From: Craig Dobson (He/Him)
Sent: 27/06/2022 2:28:18 PM
To: Council Northernbeaches Mailbox
Subject: MoD2022/0275 – DA 2020/1072 on Lot 1 & Lot 2 DP228962
Attachments: Northern Beaches DA Response 1 Drew Place.pdf;

With respect to Modification No: MoD2022/0275 – DA 2020/1072 on Lot 1 & Lot 2 DP228962 – 1 Drew Place, I am objecting to the request for modification as it will significantly infringe on our and our neighbour's privacy with a focus on:

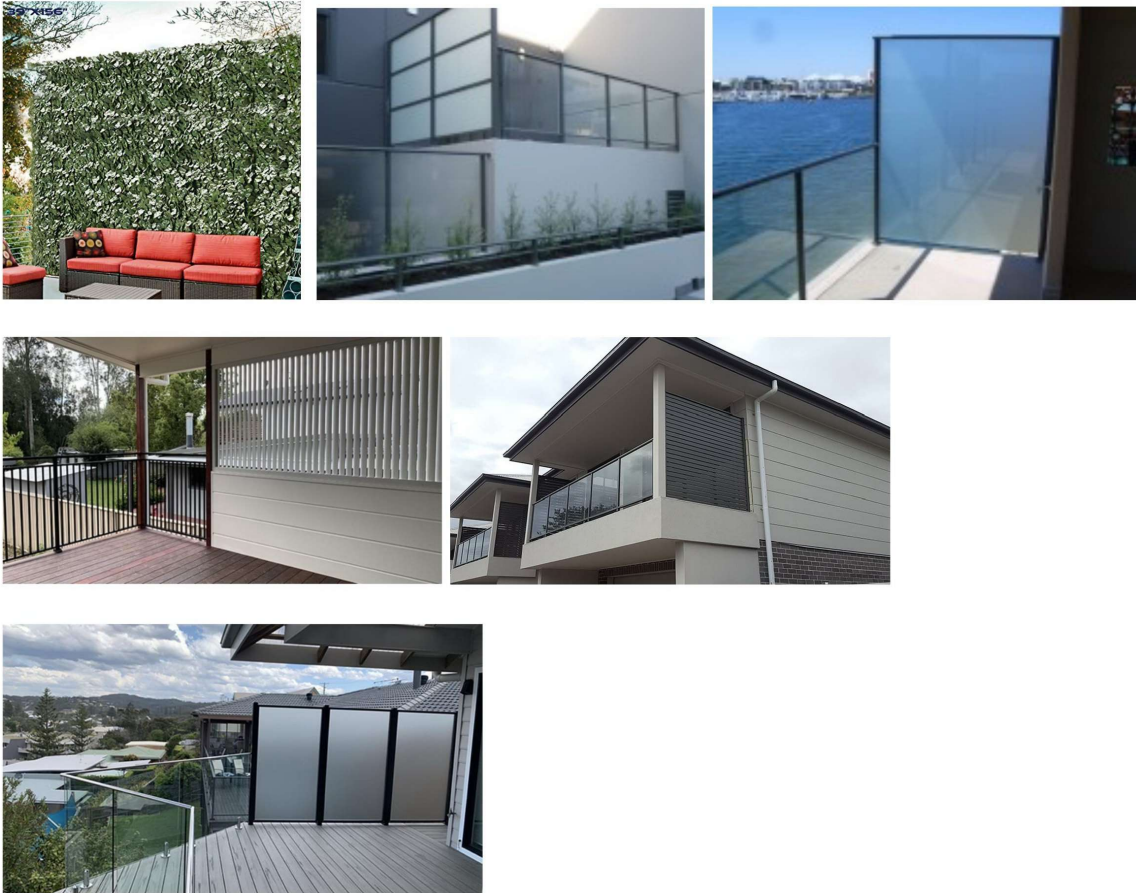
I would like to highlight that the proposed second story unit 6 that has their living area windows that face our home has a straight line-of-sight into the following areas: Son's upstairs bedroom, upstairs stairs/hallway, upstairs bathroom, downstairs kitchen, downstairs office, downstairs laundry and directly looks down on our open deck as per the below pictures.

For Point 1 on Vegetation Privacy - I would raise that the current construction process (clearing existing structure) has already removed trees that had previously provided a privacy screen exposing the rooms listed above (as you can see in the photos below) directly to where Unit 6 will be positioned. Therefore, there is an existing gap today and there is a real risk that as part of boundary remediation, the remaining trees (as highlighted by the application), would need to be removed.

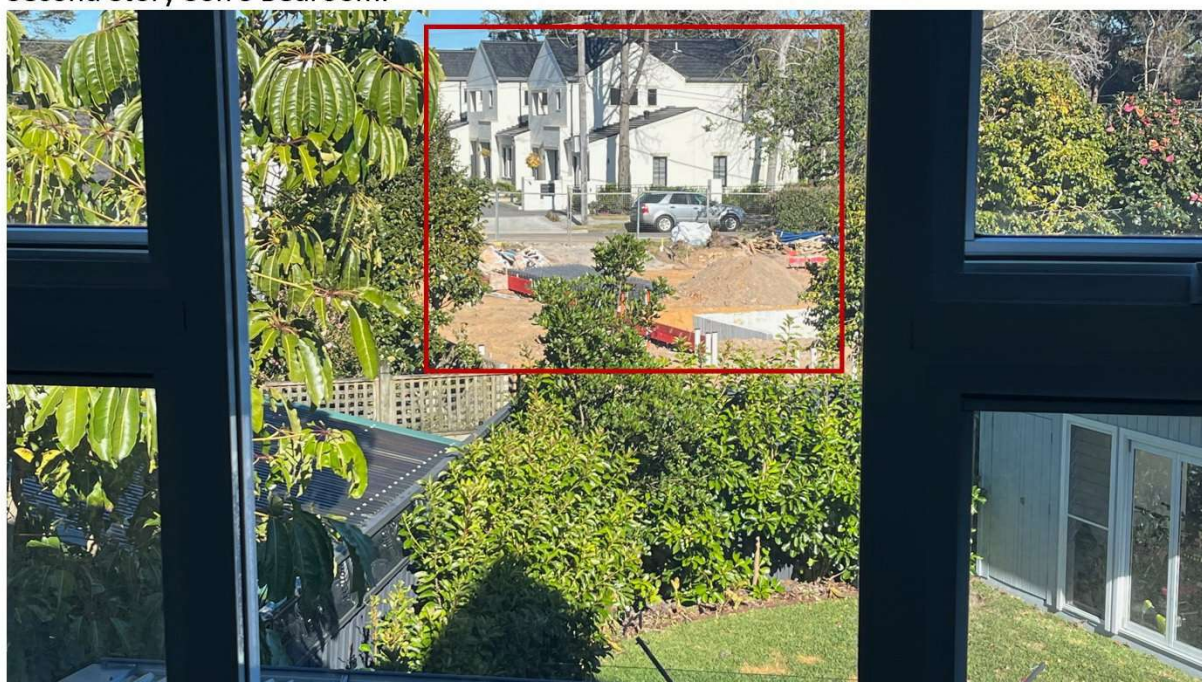
For Point 2 regarding removing condition 12(a) - I am surprised that they are unable to find a suitable supplier to develop a screen structure that meets code and integrates with Balustrading. There are many options available by a simple search that meets current Australian building standards. Here are some suggestions from Australian companies that

could meet the requirements. The appicate needs to adjust the design to meet the 12(a) requirement.
